# Site Accessibility Evaluation

### Costilla Parking Garage

Accessibility Evaluation

Finding 297249 Main Photo

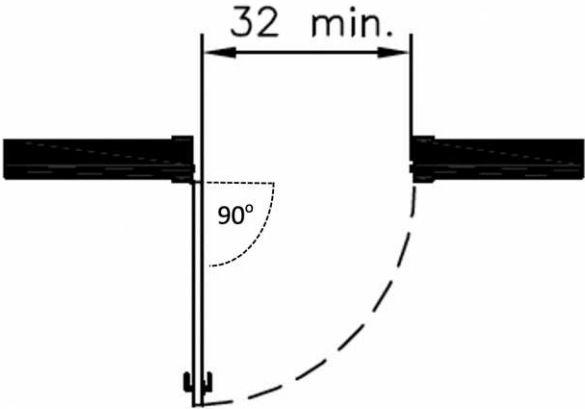
The door opening does not provide at least 32 inches between the face of the door and the opposite stop.

25.25 inches in width.  
Door located on  
northeast corner of  
Tejon and Costilla

Install door frame and door that provides a minimum width of 32 inches. Projections into the clear opening width between 34 inches and 80 inches above the finish floor or ground shall not exceed 4 inches.

Finding 297250 Main Photo

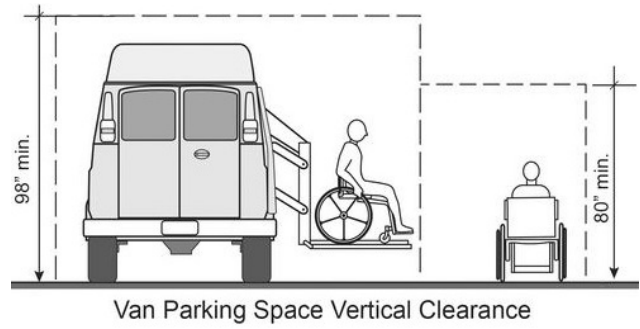
The vehicle route to the accessible parking contains vertical clearances less than 98 inches.

Parking structure  
height clearance  
maximum is 86 inches

At the moment there are no plans in constructing a new structure. Will address ADA parking to the maximum extent possible for compliance.

Finding #4 Continued

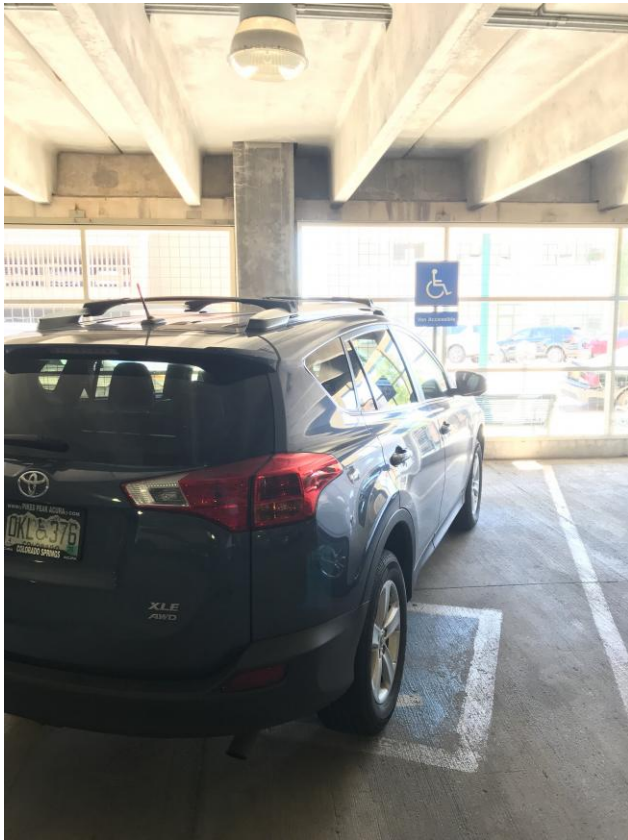
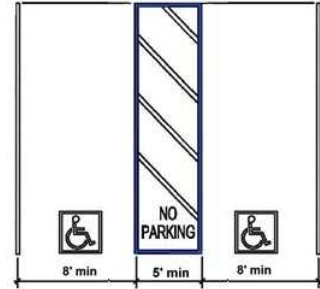
The access aisle is missing at the accessible parking stall.

Access aisle missing for 2nd accessible van parking stall

Re-configure striping to ensure 2 van stalls with 2 access aisles to the right of each van stall and 7 accessible parking stalls with a 5 foot access aisle. Since parking stalls are angled, each van stall must have its own access aisle located on the passenger side. Non-van accessible stalls may share an access aisle or van access aisle and access may be located on either side of the vehicle.

Finding 297287 Main Photo

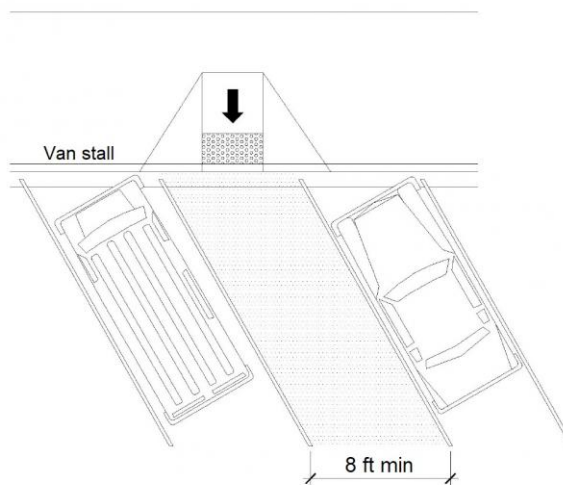
The access aisle is on the driver's side of the stall.

Access aisle on driver's side (angled parking stall)

Remove "van accessible" signage from 2nd stall. Van access aisles must be on passenger side for angled parking stalls.
